# Jacksonville Electric Authority

Subject: JACKSONVILLE ELECTRIC AUTHORITY  
ST. JOHNS RIVER POWER PARK UNITS 1 & 2  
PSD APPLICATION (PSD-FL-010)  
COMMENTS ON REVISED PRELIMINARY DETERMINATION

COMMENTS ON PSD REVISED PRELIMINARY DETERMINATION (RPD)

QUESTION D - FIGURE 1

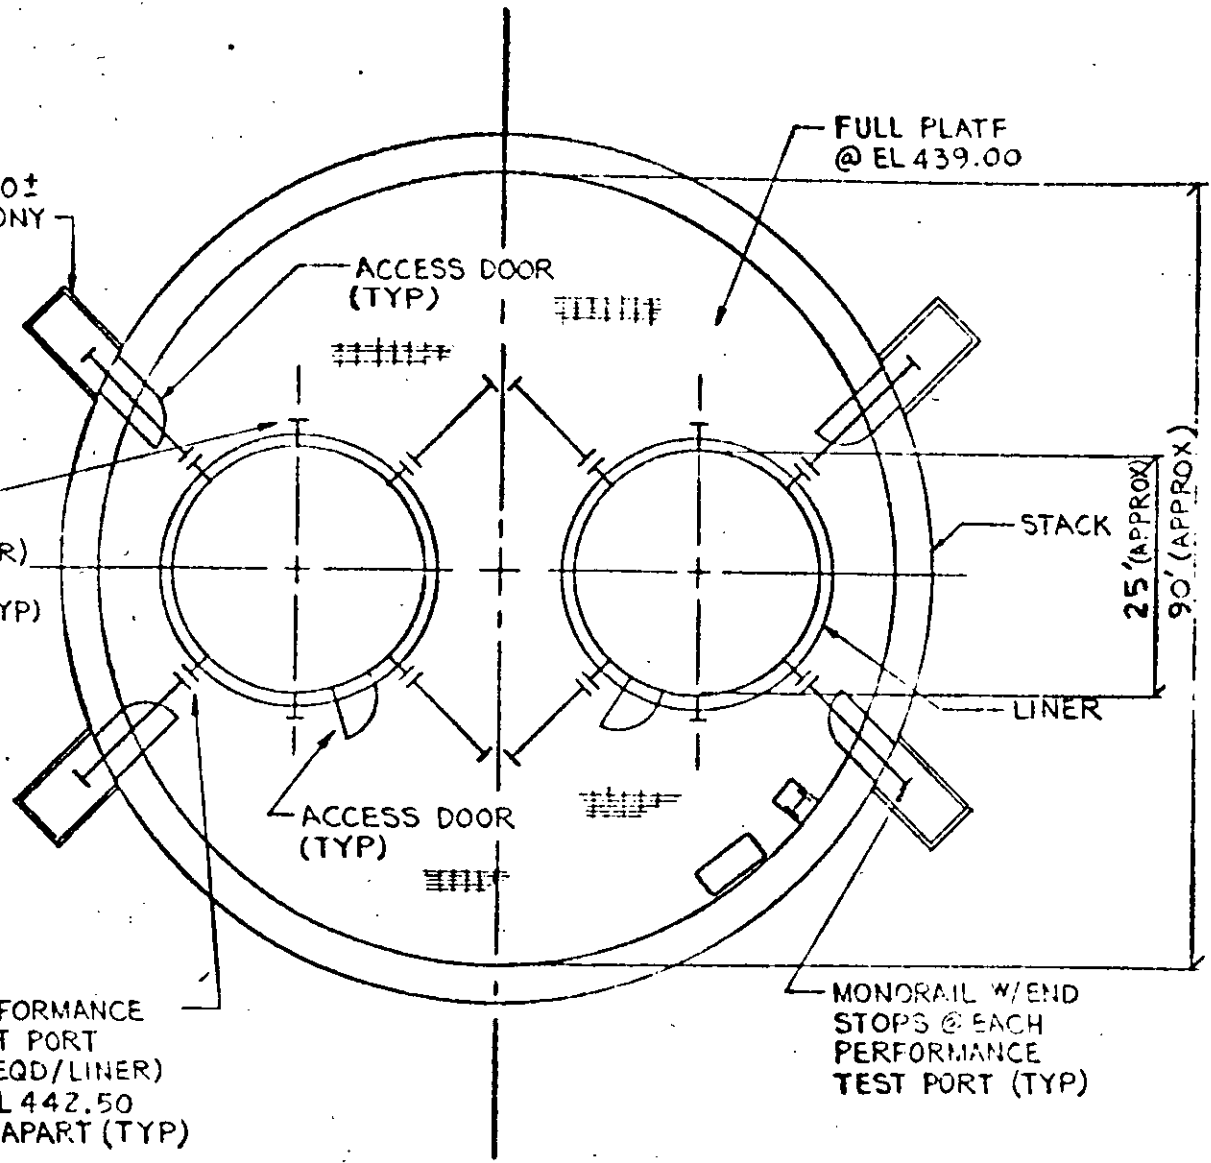
Question D:    Continuous Emission Monitors

6. The chimney liner will contain one combination SO<sub>2</sub>/NO<sub>x</sub>/CO<sub>2</sub> EPA approved monitor. Its signals will be used for EPA reporting and to provide alarms to the AQCS Control Room Operator. A diagram of the chimney cross-section at the measurement point is given in Figure 2, attached.

MONITORING  
PORT  
(2 REQD/LINER)  
@ EL 443.50  
180° APART (TYP)
